BCAC Structural work group Report of Group B proposals

Item	Topic
1	ASTM E1996 (see structural #1)
4	1905 ACI
5	2308.4.4.1
11	SOG-IBC: 1901, 1907.1

## BCAC STR #4-ACI 04 211025 IBC 1905 Clean-up

Proposed new Figure 2308.4.4.1(1) (Replace the current 2308.4.4.1(1))

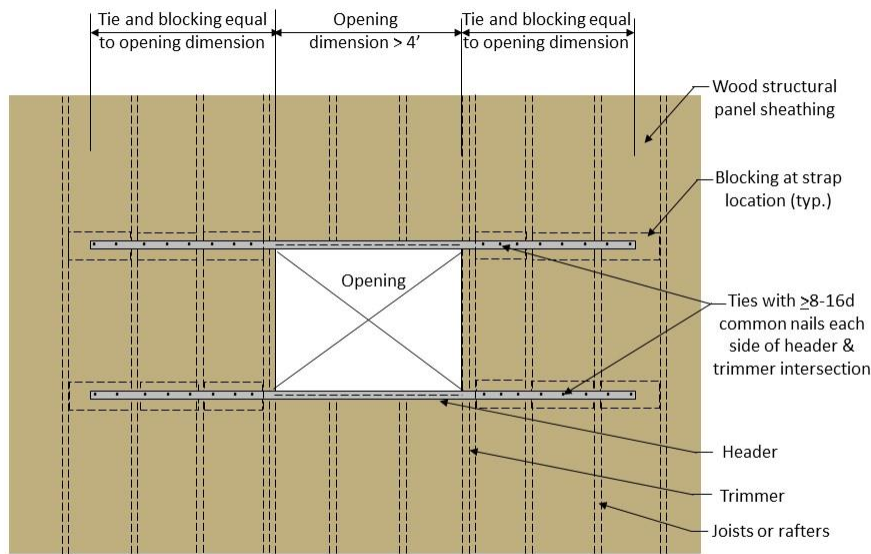
**Reason statement:** This proposal clarifies the current code text by adding “perpendicular to the joists or rafters”, replaces joist by trimmer and revise Figure 2308.4.4.1(1). The purpose of this prescriptive solution is “to strengthen openings greater than 4 feet in dimension perpendicular to the joists and provide a general means for a load path in these specific cases in lieu of requiring an engineered design.” The text of Sections 2308.4.4.1 and 2308.7.6.1 indicates that this provision applies when a floor diaphragm opening exceeds 4 feet. It details blocking and strapping perpendicular to the joists.

Sections 2308.4.4 and 2308.7.6.1 indicate that trimmers are to be doubled when the header span exceeds 4 feet, so the current Figure 2308.4.4.1(1) should be revised to show a double trimmer on each side of the opening. Since those trimmers are typically continuous, they act as collectors on either side of the opening parallel to the joists. Additional revisions to the figure as shown provide consistency with the code text. In summary, proposed changes to Figure 2308.4.4.1(1) include the following:

- Double trimmer shown on each side of the opening
- Remove vertical dimension of the opening
- Add opening dimension >4’ perpendicular to joists
- Add nailing requirements as shown based on code text

**2308.4.4.1 Openings in floor diaphragms in Seismic Design Categories B, C, D and E.** Openings in horizontal *diaphragms* in *Seismic Design Categories B, C, D and E* with a dimension that is greater than 4 feet perpendicular to the joists or rafters shall be constructed with metal ties and blocking in accordance with this section and Figure 2308.4.4.1(1). Metal ties shall be not less than 0.058 inch [(16 galvanized gage)] in thickness by 1½ inches in width and shall have a yield stress not less than 33,000 psi. Blocking shall extend not less than the dimension of the opening in the direction of the tie and blocking. Ties shall be attached to blocking in accordance with the manufacturer’s instructions but with not less than eight 16d common nails on each side of the header- joist trimmer intersection.

**2308.7.6.1 Openings in roof diaphragms in Seismic Design Categories B, C, D and E.** In buildings classified as Seismic Design Category B, C, D or E. openings in horizontal diaphragms with a dimension that is greater than 4 feet (1219 mm) perpendicular to the joists or rafters shall be constructed with metal ties and blocking in accordance with this section and Figure 2308.4.4.1(1). Metal ties shall be not less than 0.058 inch [1.47 mm (16 galvanized gage)] in thickness by 1½ inches (38 mm) in width and shall have a yield stress not less than 33,000 psi (227 Mpa). Blocking shall extend not less than the dimension of the opening in the direction of the tie and blocking. Ties shall be attached to blocking in accordance with the manufacturer’s instructions but with not less than eight 16d common nails on each side of the header- joist trimmer intersection.
